ADDENDUM # 1

Bid 20C4, Veneer Repairs to Thurmont Primary School

THURMONT PRIMARY SCHOOL

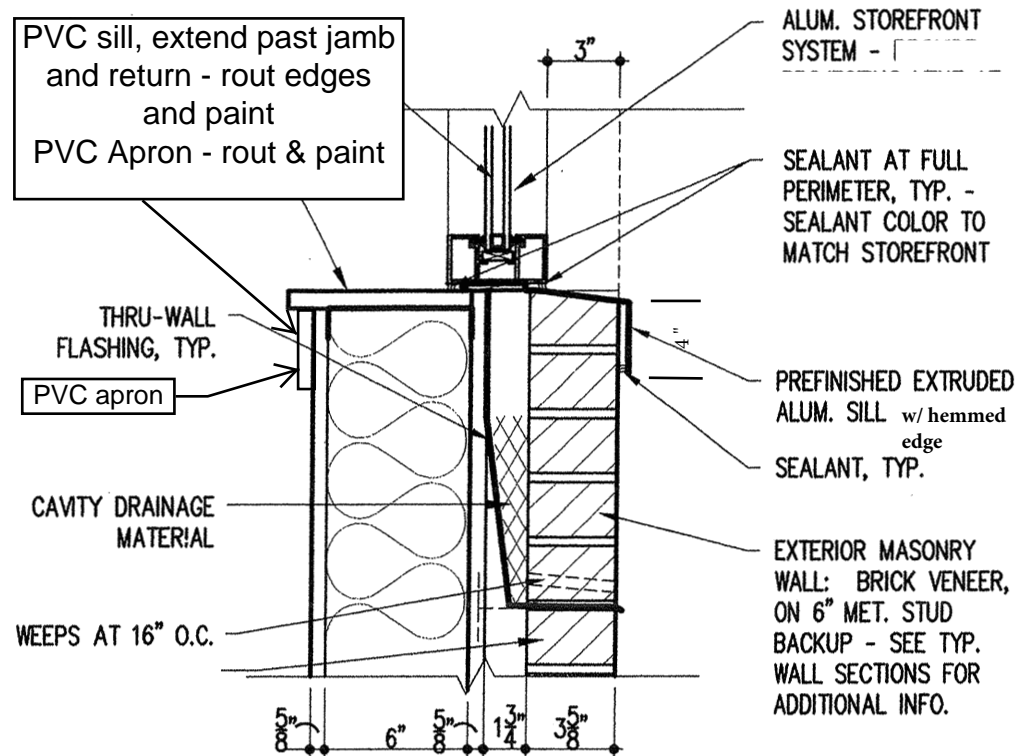
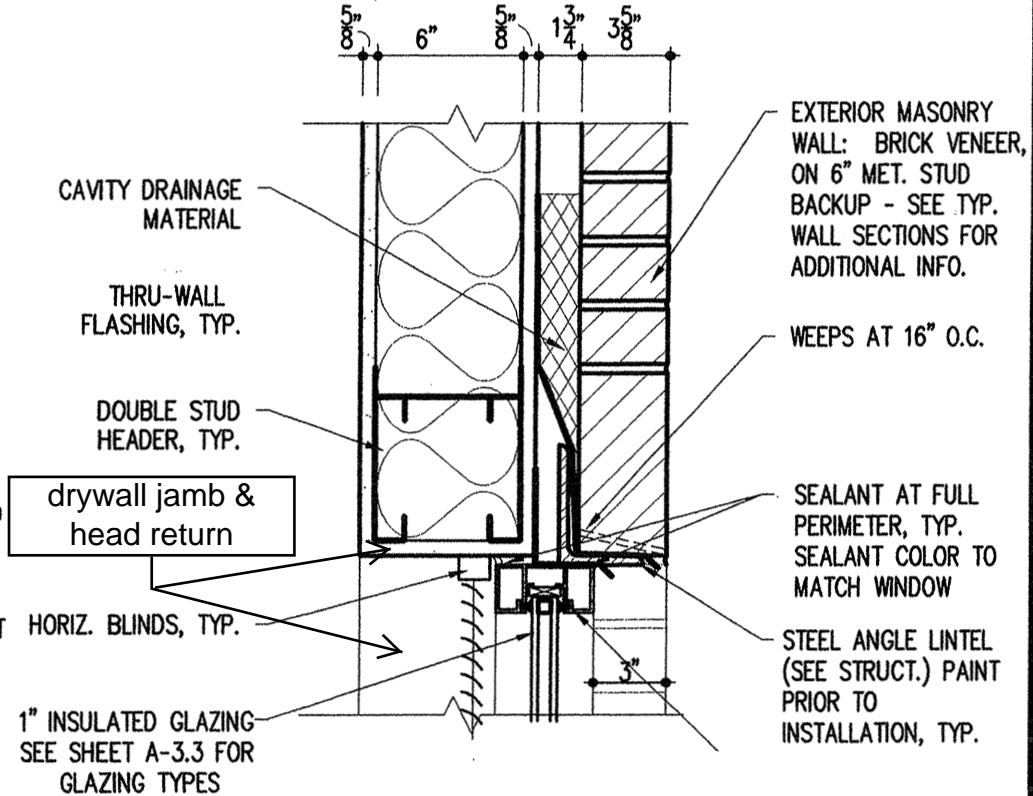
3: Please provide detail of window sills.

QUESTION: Please provide approximate window sizes/details. The drawings do not appear to be a standard scale and no scale is noted.

12. QUESTION: Clarify the interior sill condition at the windows. Detail 1 on TPS-A-04 makes it look like it extends an inch or so past the drywall. Is this sill aluminum and part of the window? The YKK site does not show any that overhang as shown at this detail.

ANSWER: See attached sketch – provide a PVC or solid composite product for the sill and apron underneath. Extend the sill past the sidewall jambs with wall return. Ease the sill/apron edges with a router and paint. The window jambs shall receive interior drywall return w/termination accessories and painted with the wall color. The Minimum sill thickness shall be $\frac{3}{4}$ inch. Apron shall be $\frac{3}{4}$ inch thick and height coordinated with the backsplash, not to exceed 4 inches.

ANSWER: the existing stud to stud window opening is measured as 33.5 inches in width and sill to header height is approximately 73 inches. Color to be white. Unit is inoperable, no screens, 5 glass lights equally spaced in the opening. See attached detail from original construction.

13. ANSWER: See RFI #1 & sketch

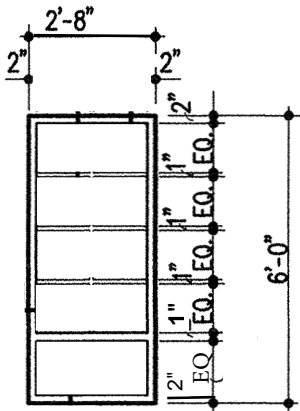
QUESTION: What material should we provide for the new back splash? How high?

ANSWER: a PVC or solid composite material is approved. Height to be coordinated with the window sill, & apron, approx. 4 inches above the countertop. The backsplash shall be painted to closely match the countertop color, and may be fastened thru the face into its anchoring feature.
